CITY OF SAN ANTONIO

Re: The Bolders at Canyon Springs (Enclave) Subdivision MDP # 806A

The City Staff Development Review Committee has reviewed The Bolders at Canyon Springs (Enclave) Subdivision Master Development Plan M.D.P. # 806A. Please find enclosed a signed copy for your files. Your plan was accepted, however please note the following:

MASTER DEVELOPMENT PLAN FOR THE BOULDERS AT CANYON SPRINGS
(ENCLAVE SUBDIVISION)

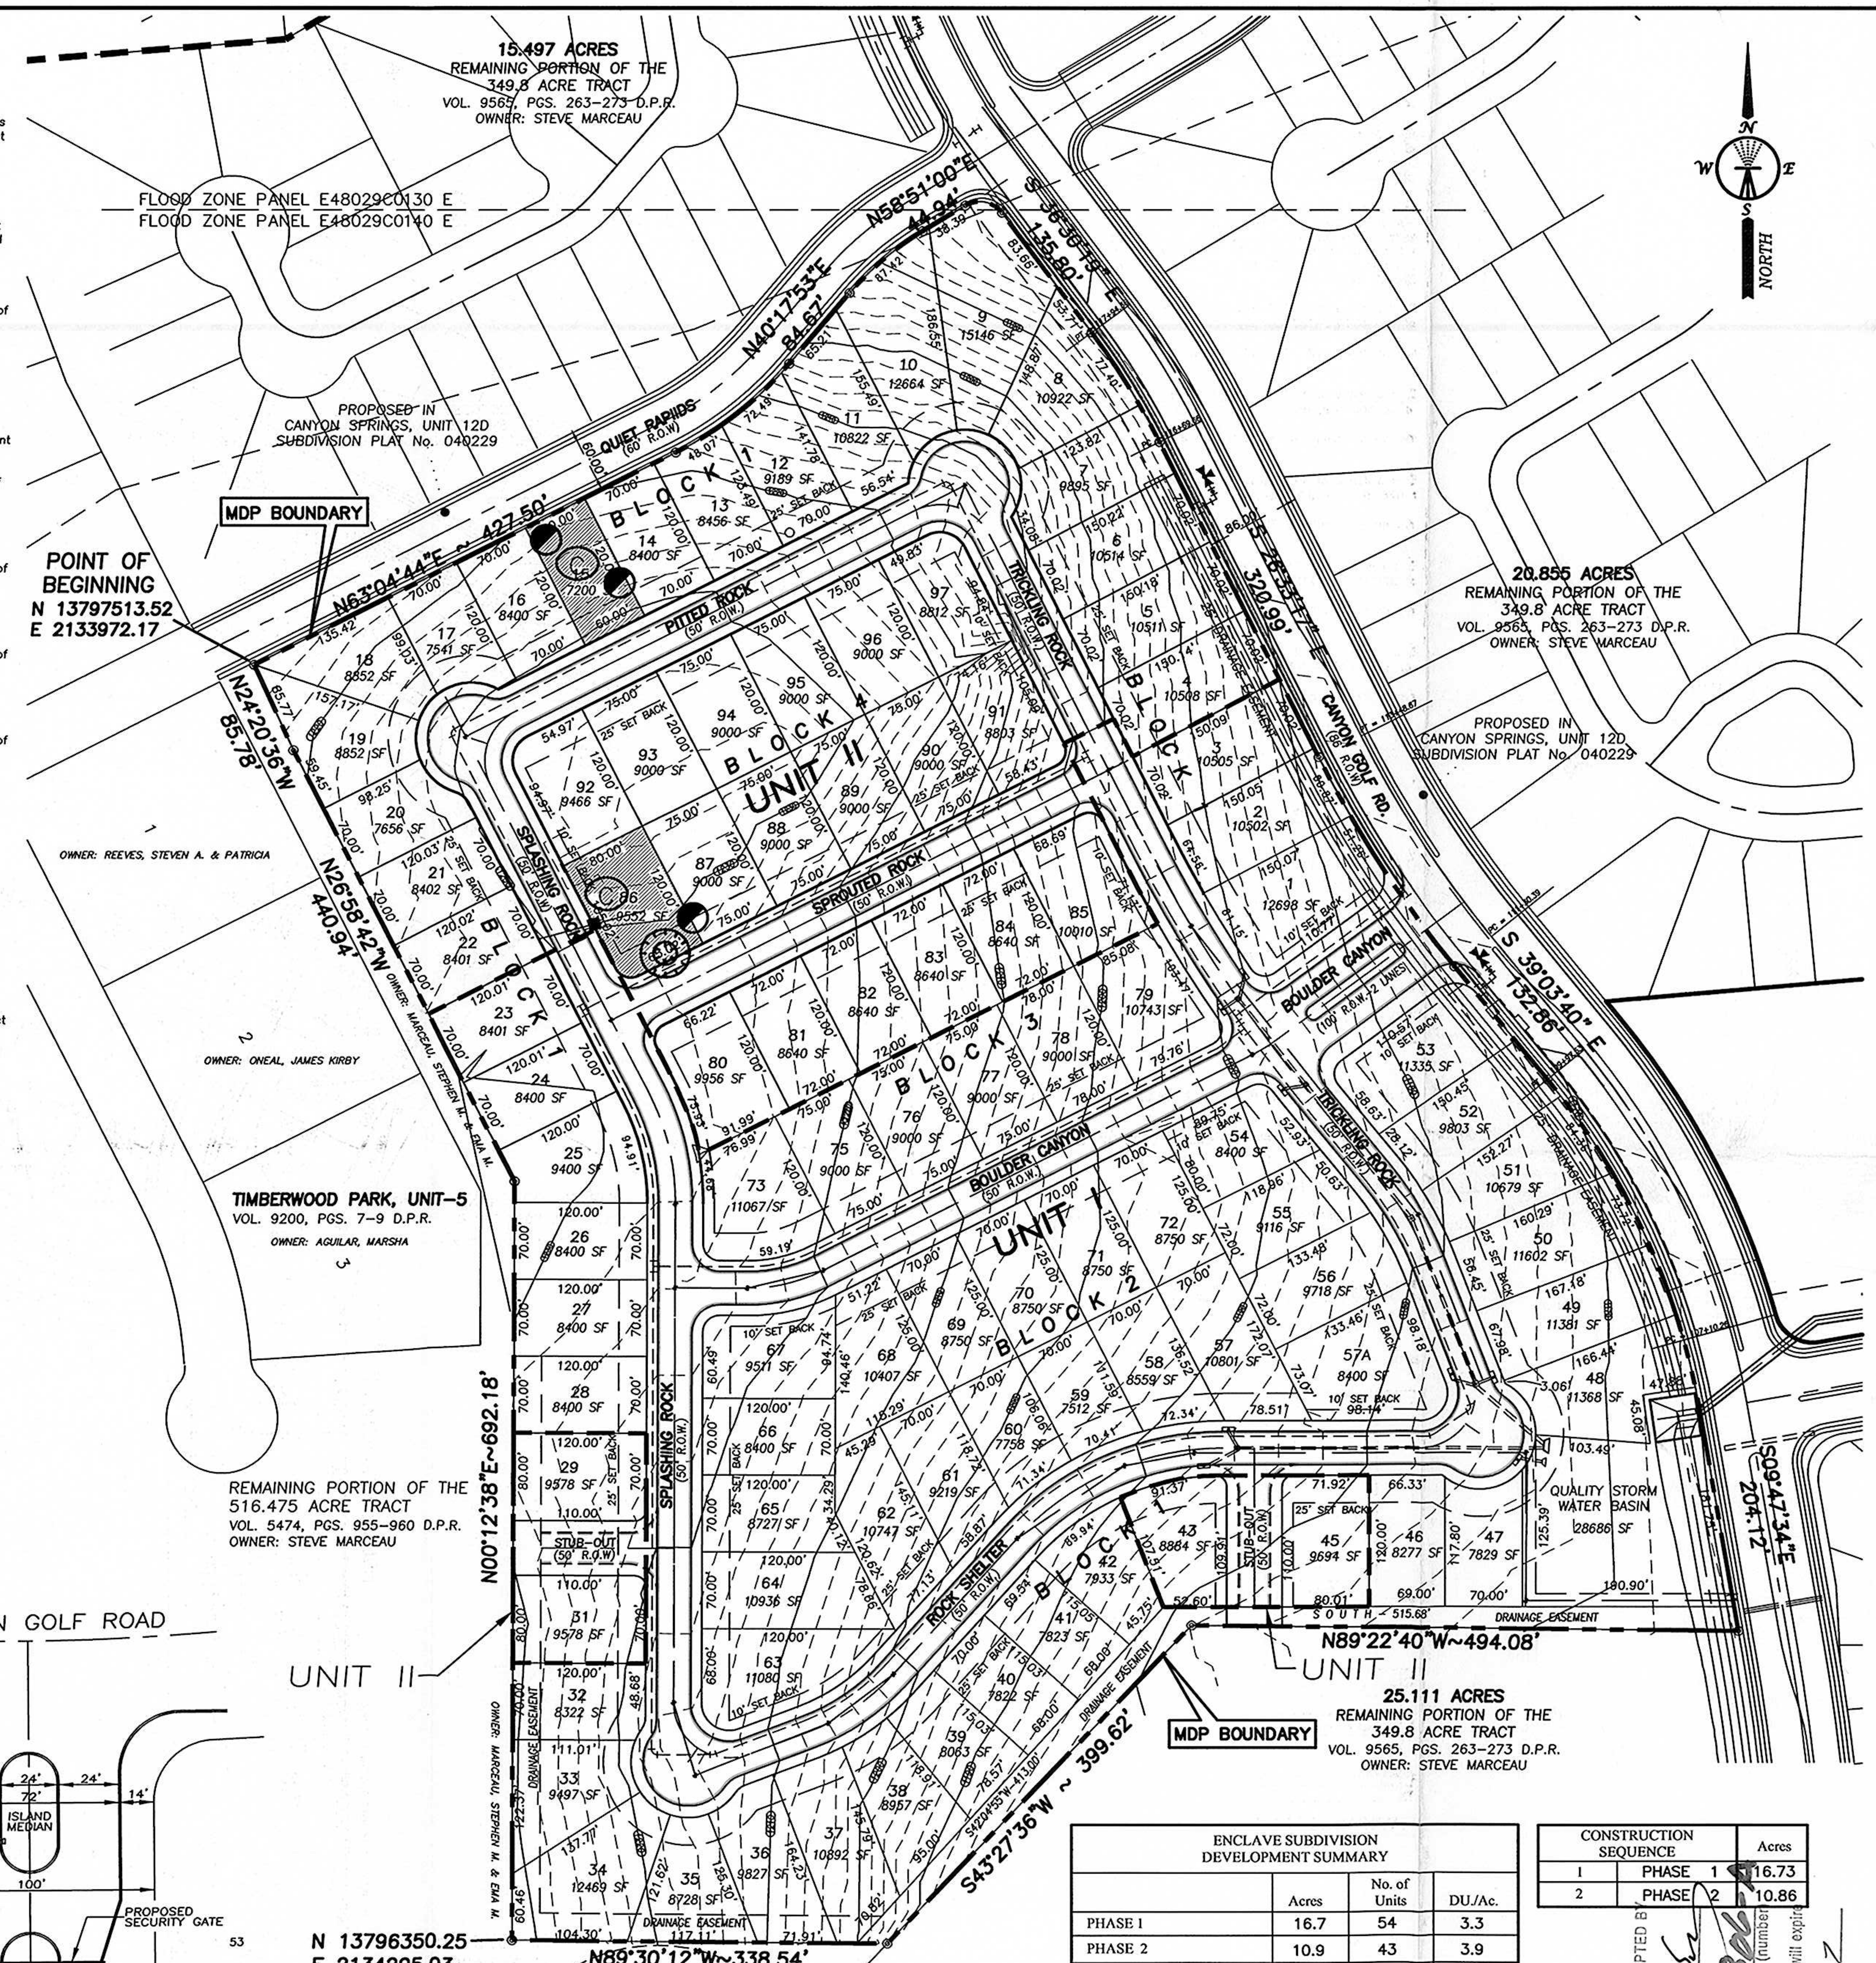
- In consideration of public safety and convenience, excessive grades by reason of topography should be avoided in street layouts and arrangements.

- The acceptance of this Master Development Plan # 806A is confined to the boundary limits of the site. Any projection(s) of future roadways outside the boundaries does not infer any set alignment of future roadways. All major arterials and streets shall follow all regulations.

- Storm Water Engineering will require the following items at the time of platting:
    1. There is a high probability that the revised MDP that includes street stub-outs will change the direction of drainage and subsequently the drainage discharge points.

2. It appears an underground system is proposed to accommodate the direction of water due to the street stub-outs.

3. Given the steep slopes (terrain) it will be difficult to design adequate "sump" condition inlets to "pick-up" the storm water. The possibility of additional underground storm water may be required.
